Product /Process Change Notification

PCN Number:PCN-20200065

Add additional manufacturing site (Lite-On Thailand factory) of MFP packages

MFP packages: LTV-300 series

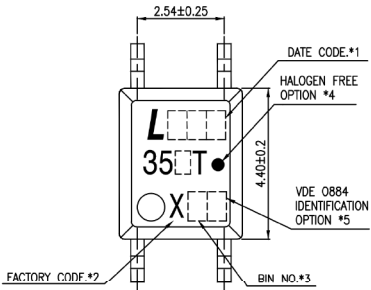
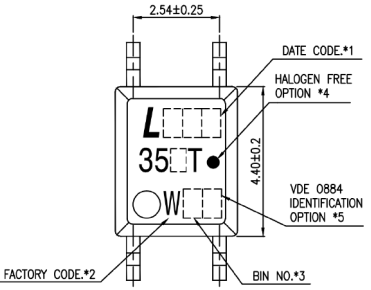
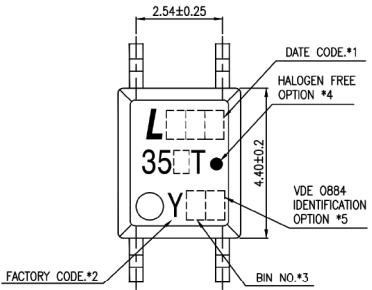
Lite-On uses identical materials all 3 factories Thailand, Tianjin and Changzhou site

Factory identification mark shall be marked (W: China -CZ, X: China -TJ, Y: Thailand -Y)
